D
C
B
A
UNCLASSIFIED
DP2 SUBMISSION - P1338 BUILDING - PRE-FINAL SUBMISSION

DEPARTMENT OF THE NAVY
 NAVAL FACILITIES ENGINEERING COMMAND
 NAVAL FACILITIES ENGINEERING COMMAND ~ MID-ATLANTIC
 ROICC FLORENCE CAMP LEJEUNE
 JACKSONVILLE, NC
 JACKSONVILLE, NC
 P1338 II MEF SIMULATION/TRAINING CENTER
 REPLACEMENT
 PLUMBING - UNDERGROUND PLAN - AREA A

PLUMBING - ENLARGED PLAN - UNDERGROUND AREA A

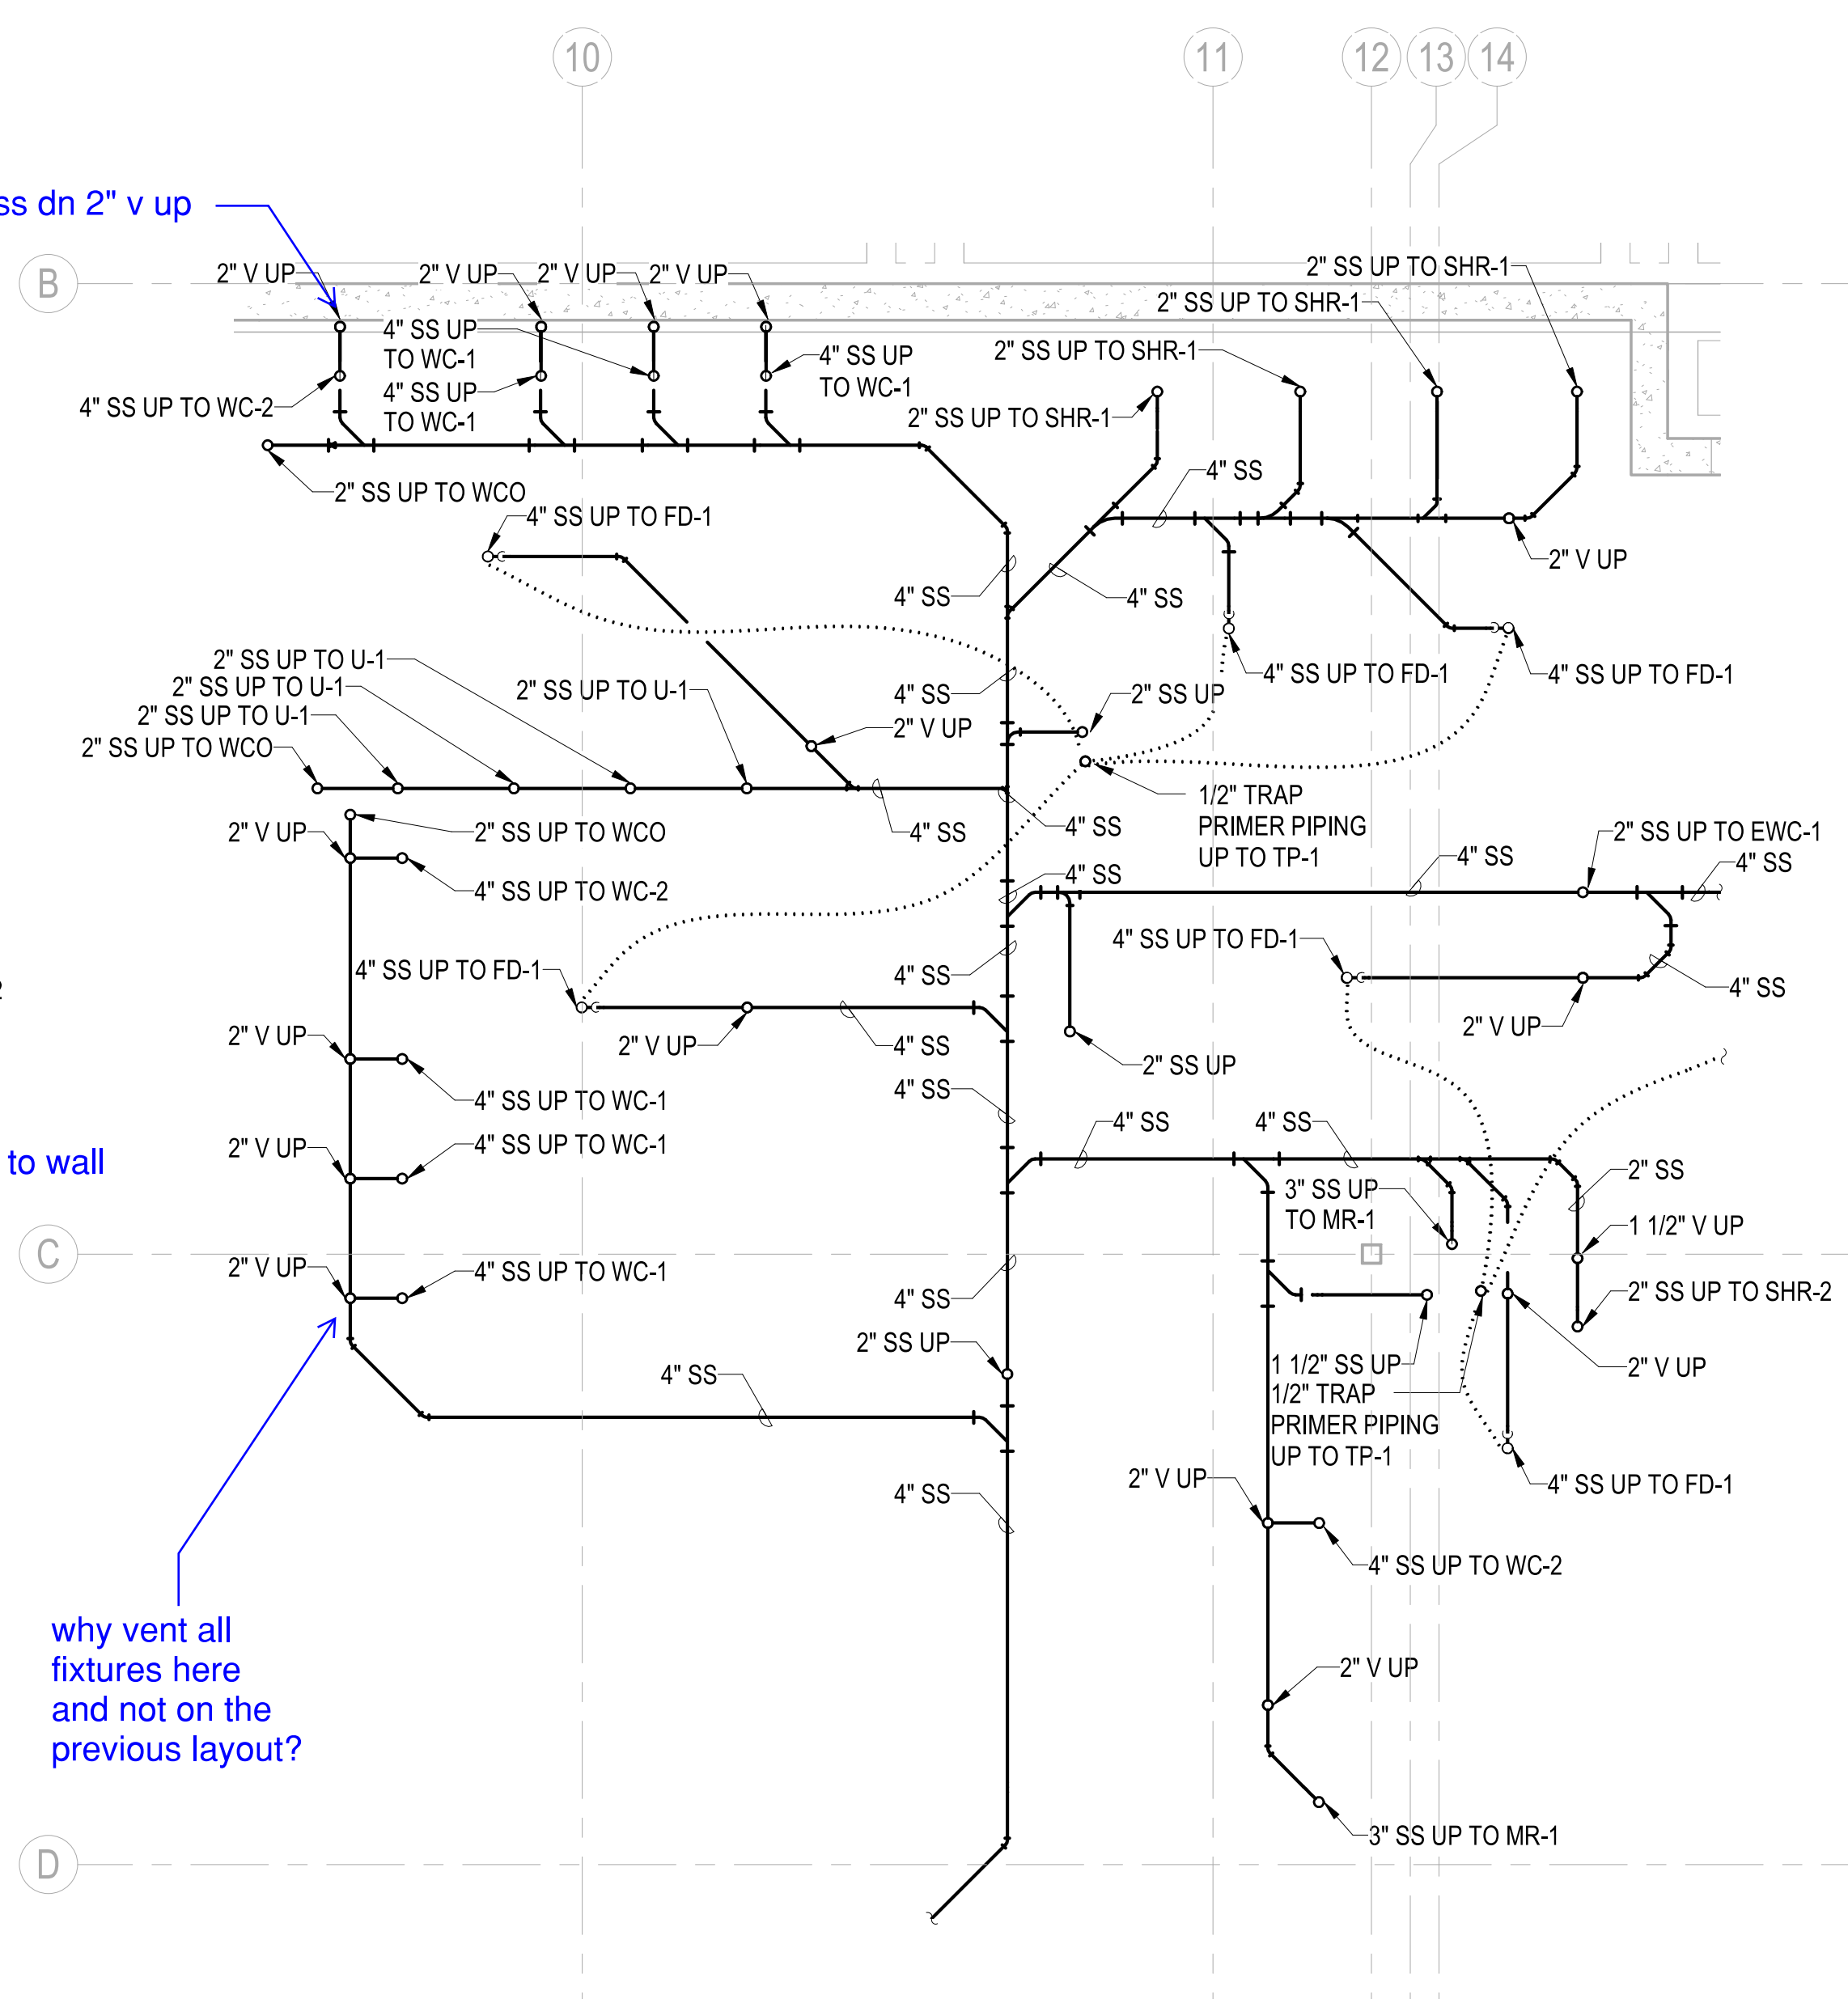
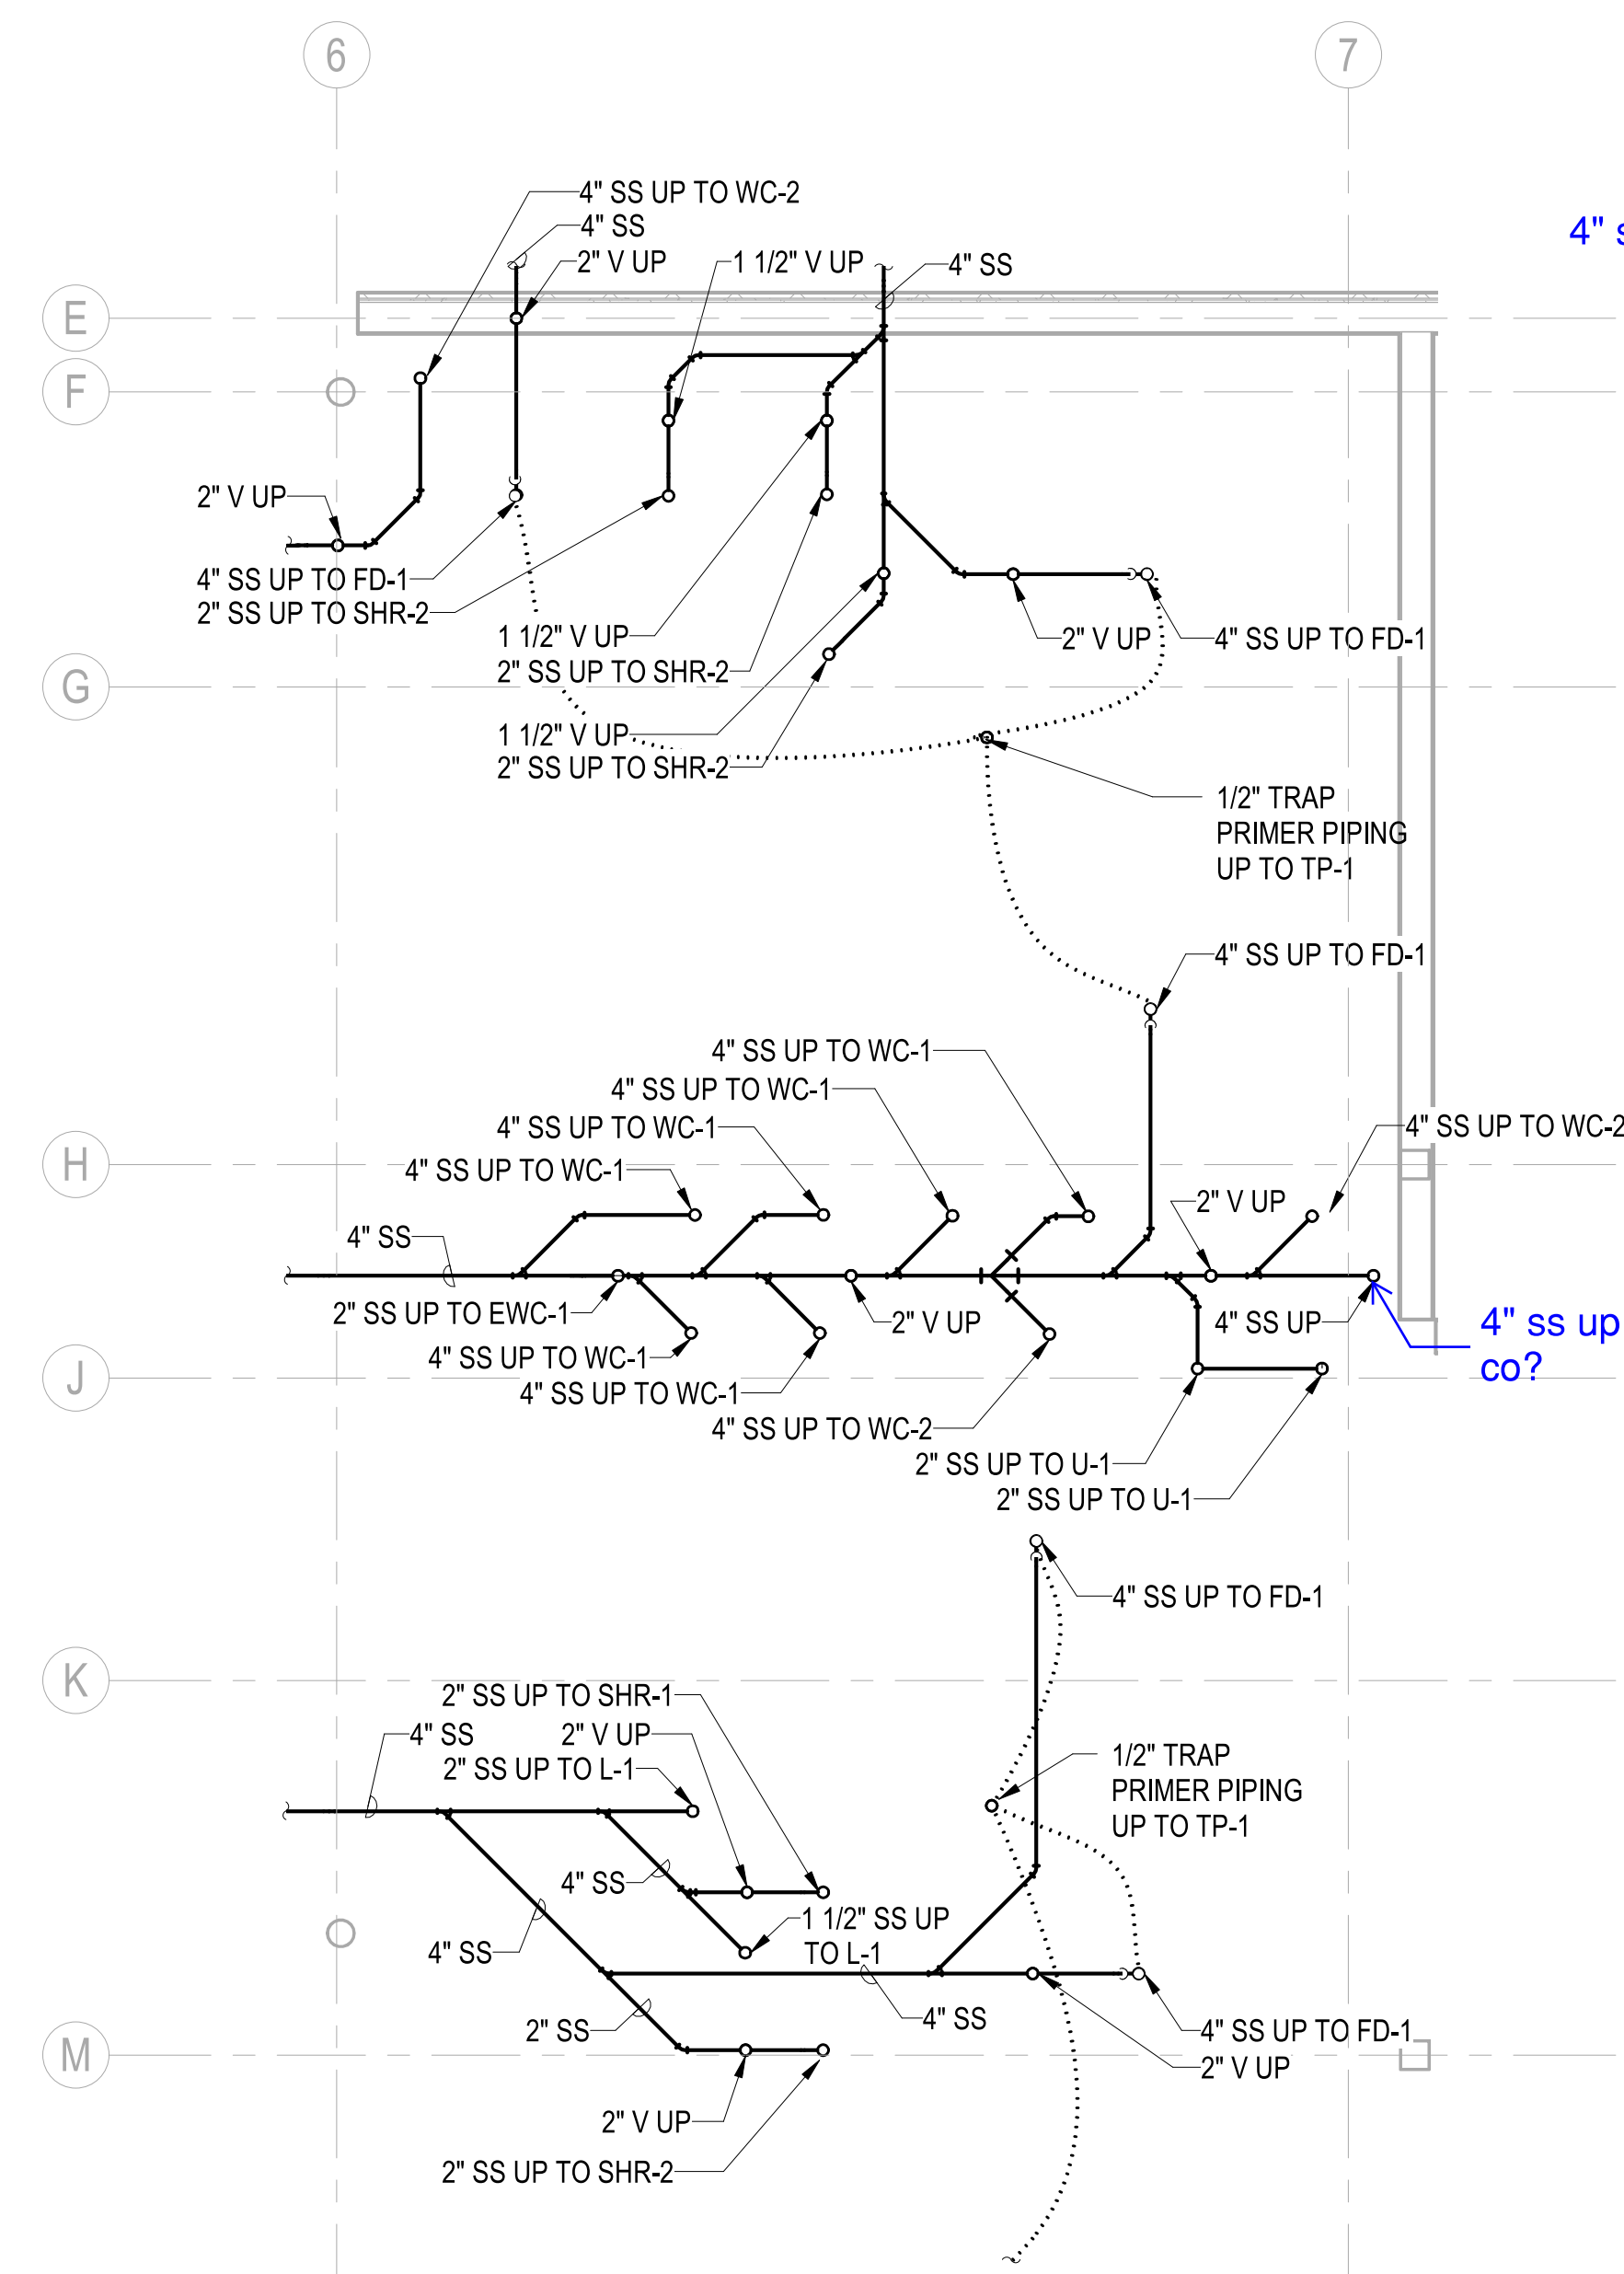
4" ss dn 2" v up

4" ss up to wall co?

why vent all fixtures here and not on the previous layout?
